ADDENDUM 1 TO BID DOCUMENTS FOR THE
TANGIPAOHA PARISH GOVERNMENT - LAKE PONTCHARTRAIN
SHORELINE PROTECTION PROJECT
TANGIPAOHA PARISH, LOUISIANA

May 9, 2023

**ADDENDUM 1 TO BID DOCUMENTS
LAKE PONTCHARTRAIN SHORELINE PROTECTION PROJECT**

1
C05 C14
DETAIL - LIGHTED DAYBEACON
NOT TO SCALE

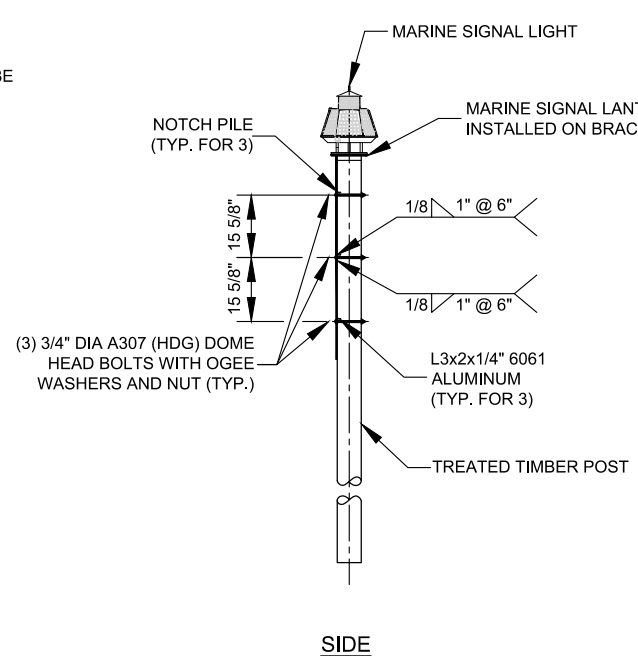
3. **REPLACE** Sheet C14 with attached revised Sheet C14 to clarify and revise required length of treated timber post in Detail 1.

12. **Question:** Please clarify the length of the treated poles for the permanent nav aids. The drawings (sheet 16 of the pdf, C-14) show 50' poles, but the specs 35 12 73, paragraph 2.01, require 60' poles. What is the required length?

Answer: Treated timber posts for Lighted Daybeacons shall be 60' long. See revised Sheet C14 referenced in Section III, Item 3 above.
